SUBJECT: Forwards proprietary & non-proprietary response to NRC 990317
 RAI re TR DPC-NE-3005-P, which describes new Duke methodology
 for analyzing Oconee UFSAP Chapter 15 non-LOCA transients &
 accidents. Proprietary info withheld, per 10CFR2.790.

Subject: Oconee Nuclear Station
Docket Numbers 50-269, -270, -287
UFSAR Chapter 15 Transient Analysis Methodology,
Topical Report DPC-NE-3005-P, Revision 1

Responses to Request For Additional Information
DPC-NE-3005P Revision 1

Figure 12

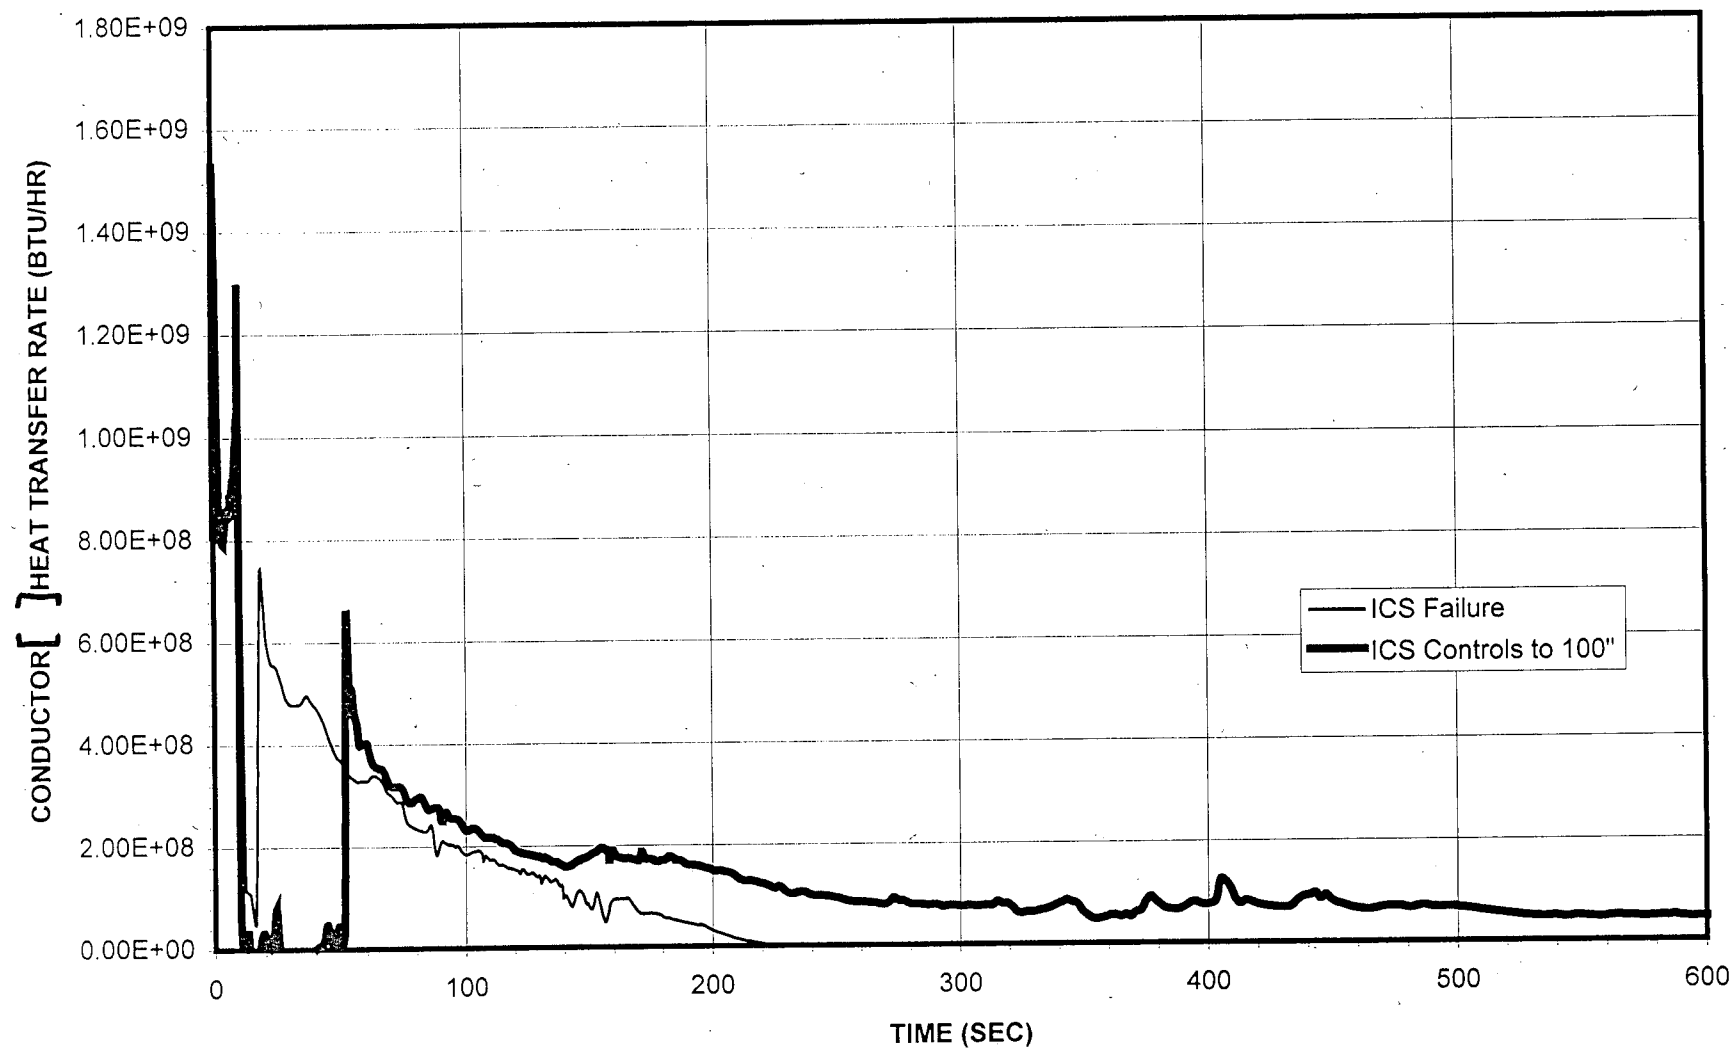
- Q6. Page 15-14 states that the limiting assumption with respect to maximizing overcooling and reactivity addition has been determined by analysis to be the case when the Integrated Control System (ICS) is controlling main feedwater. This case was found to cause more overcooling than the case that assumes failure of the ICS, which would permit unlimited main feedwater addition to the affected steam generator. Provide comparisons of the conditions within the affected steam generator secondary that would cause the ICS operating case to be the worst case. Compare steam generator level, pressure, temperature, and heat transfer coefficients that are calculated by the RETRAN code.

Figures 7-16 show the heat transfer coefficient and the heat transfer rate for [] steam generator tube conductors. The [] were selected to show the axial variation in the predictions. The elevation and height of each conductor above the lower tubesheet are as follows:

Under full power steady-state conditions, the SG tube bundle heat conductors exhibit well defined heat transfer modes. The lower bundle region (Conductors []) contains a relatively large amount of liquid, and is in the nucleate boiling heat transfer mode. The middle bundle region (Conductors []) contains a larger ratio of steam to liquid, and is in the forced convection vaporization heat transfer mode. The upper bundle region (Conductors []) contains steam and is in the forced convection to superheated vapor heat transfer mode. During the blowdown phase of the MSLB, conditions within the SG undergo a violent change. The decompression of the steam generator causes liquid in the lower region of the tube bundle and in the downcomer to be transported to higher elevations within the tube bundle by entrainment in the high velocity steam flow. Due to the severe pressure reduction, flashing occurs in the downcomer and results in reverse flow through the aspirator port. The reverse aspirator port flow contributes to a second boiling region in the upper tube bundle. Upper tube bundle conductors, which are at the hottest temperatures, are

periodically quenched with slugs of entrained liquid. For the ICS failure case, the SG gradually fills with liquid after the initial blowdown and experiences less boiling. The accumulation of subcooled liquid as the overfill progresses results in RETRAN predicting the forced convection to subcooled liquid heat transfer mode. For the ICS controlling to 100 inches case, MFW flow is unstable as the ICS attempts to maintain the level setpoint. During periods of high MFW flowrates the liquid levels within the tube bundle increase, causing heat transfer behavior similar to the initial blowdown. During periods of low MFW flowrates, the hotter tube bundle regions dry out. As the temperature differences between the primary and secondary decrease as the analysis progresses, heat transfer coefficients and rates decrease for all conductors for both cases. The integral effect of the heat transfer predicted for each tube bundle conductor is described in the preceeding paragraphs. The overall heat transfer rate, and therefore the consequences of the two MSLB cases are quite similar, with the case with ICS controlling to the level setpoint slightly more limiting.
